## Committee of the Whole Report

**Subject:** Rezoning Application No. 00904 for 1101 Yates Street and associated Development Permit with Variances Application No. 00301

**Figure 6: Areas of angled east and west façade (shown in green)**

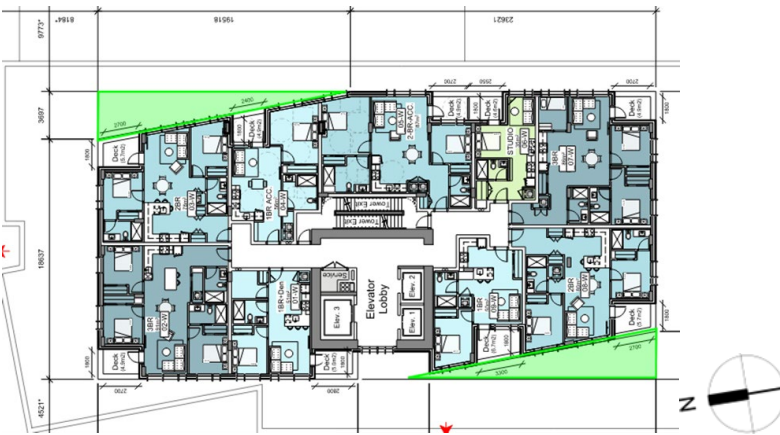
The tower portion of the proposal is approximately 43m north-south; therefore, in accordance with the guidelines, there should be a significant vertical break in the façade to mitigate the appearance of the building mass. There is a significant vertical break of approximately 5.5m in the west facing façade, but no such break exists for the east facing façade.

The proposed building does angle portions of the east and west façade to reduce the massing along one plane as shown in Figure 6. This angling of the façade mitigates the impact of not incorporating a vertical break.
